**Addendum No. 1
January 19, 2017**

Project: Roof Replacement – EEP Building
South Dakota School of Mines & Technology
Rapid City, South Dakota

OSE #R0715-05X
AI Project No. 2604
Bid #2

Architect: Architecture Incorporated

1
SD-1

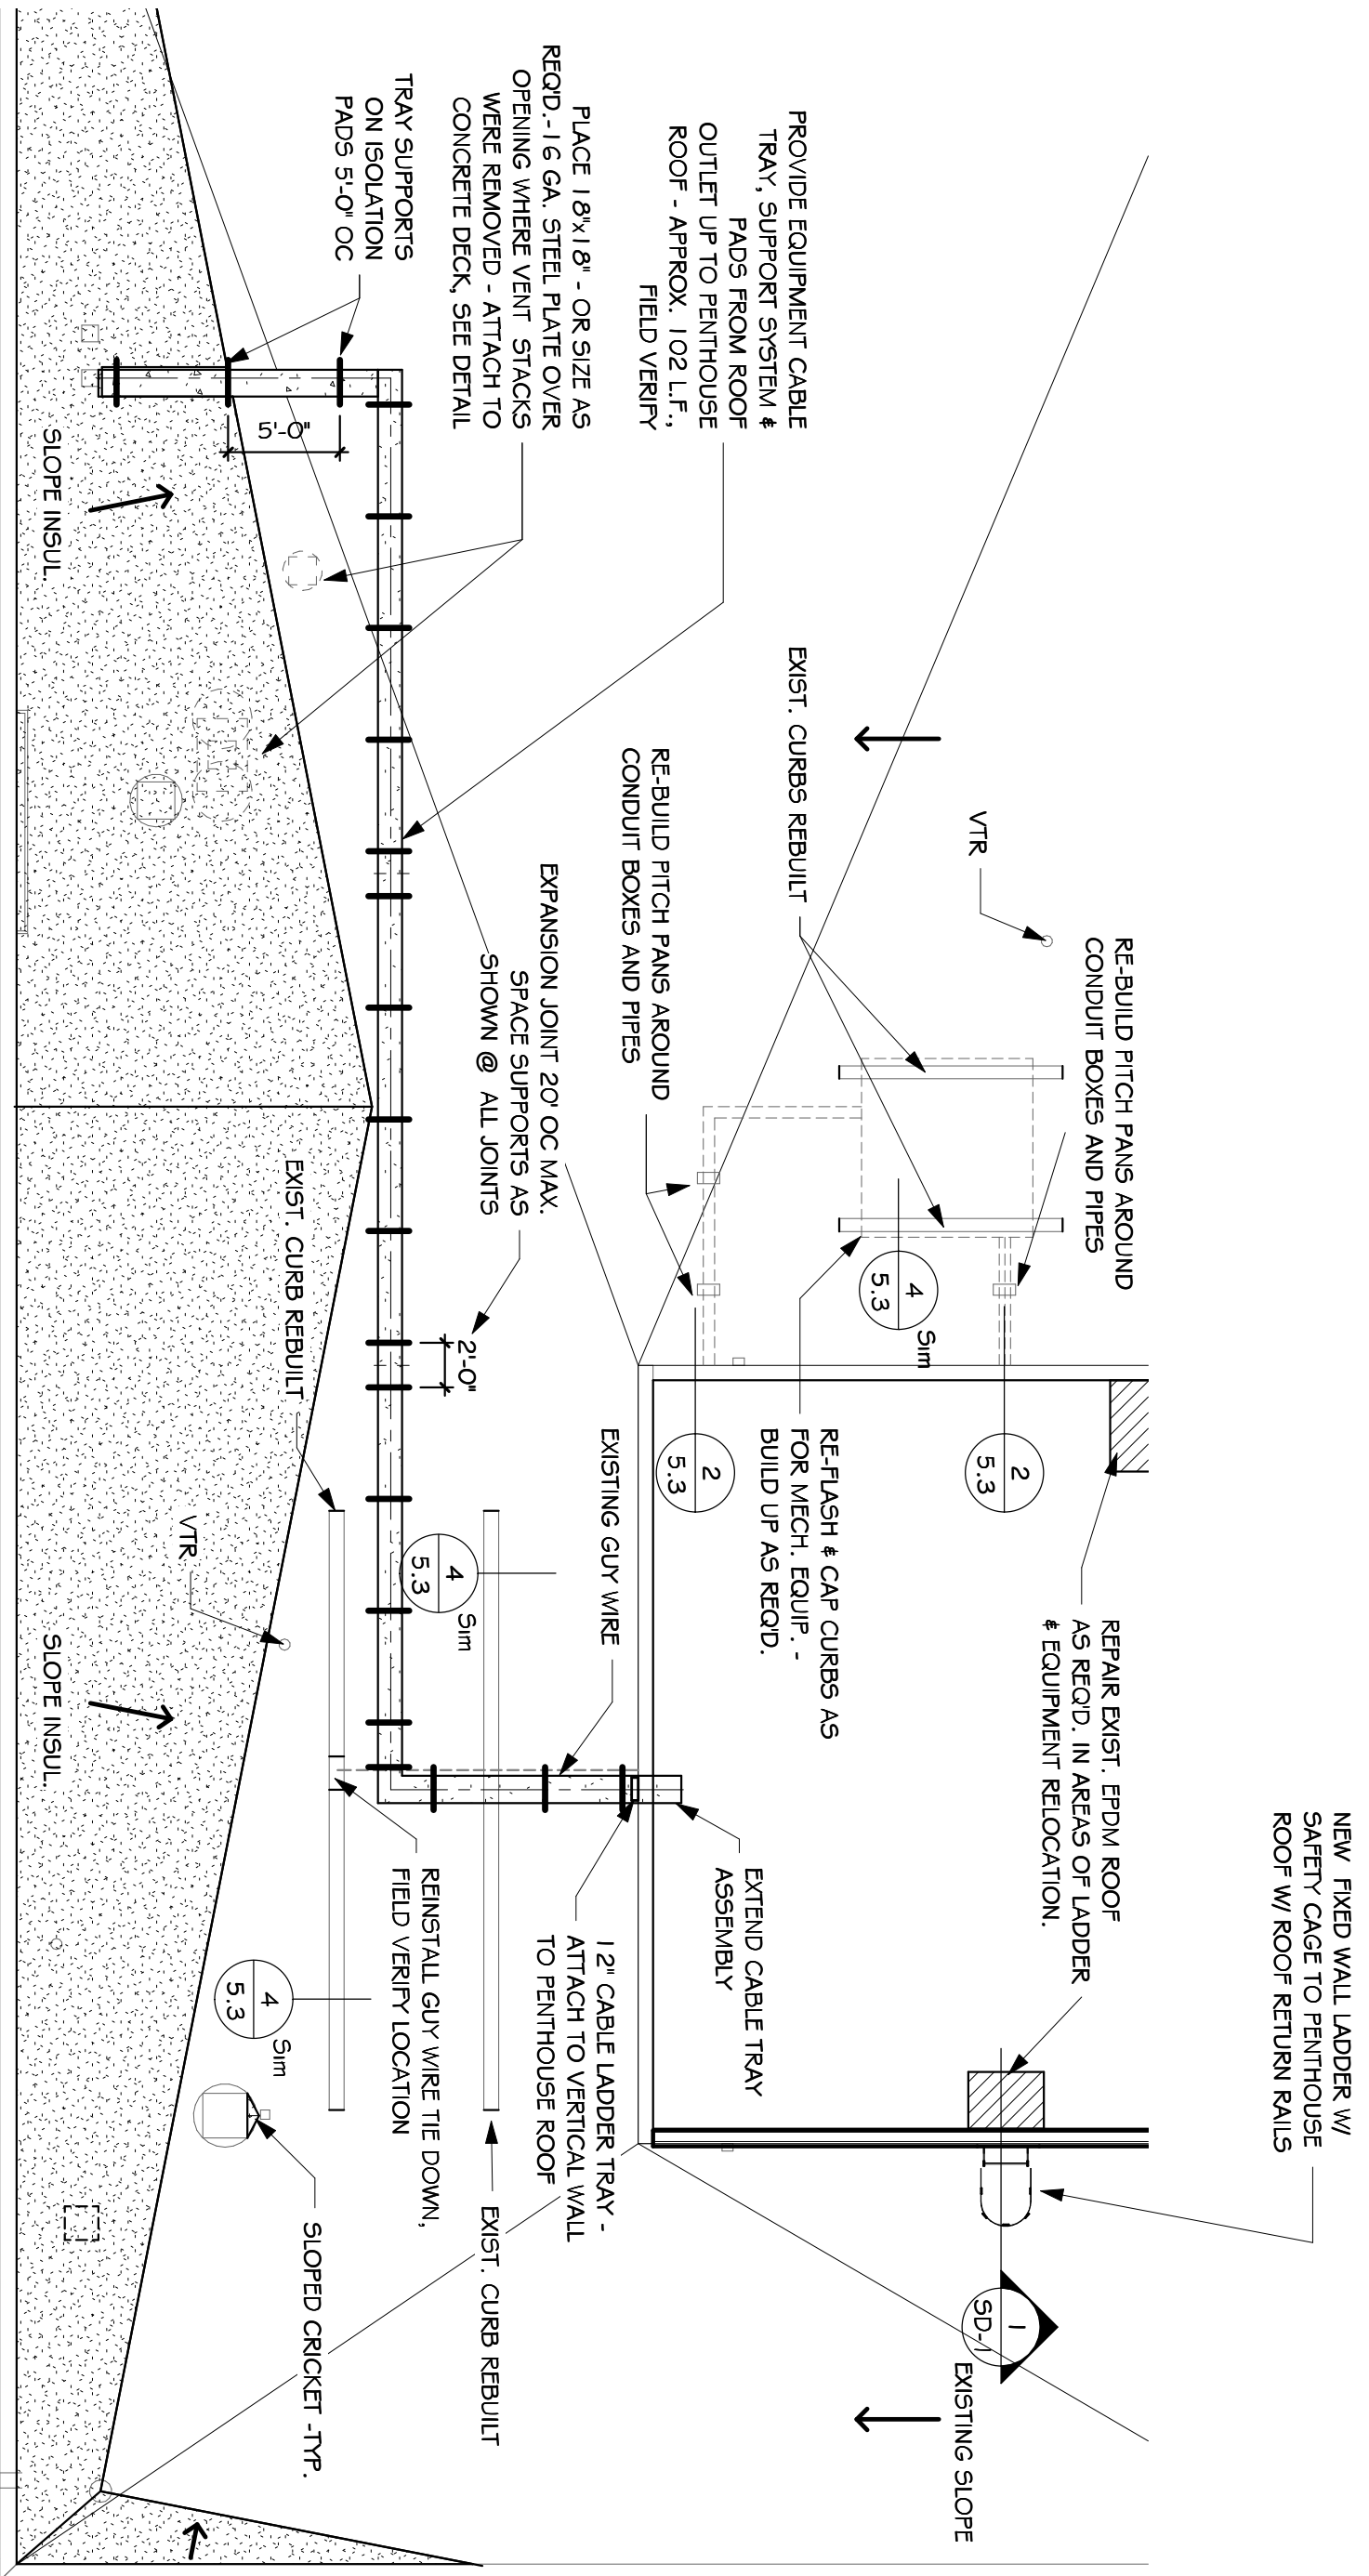
- c) Roof ladder: See attached Supplemental Drawing SD-1 for section detail through new roof ladder. Attach the new ladder and cage to the existing steel and gable bracket frame. The width of the brackets is approximately 16” – field verify width and roof elevation prior to fabrication.
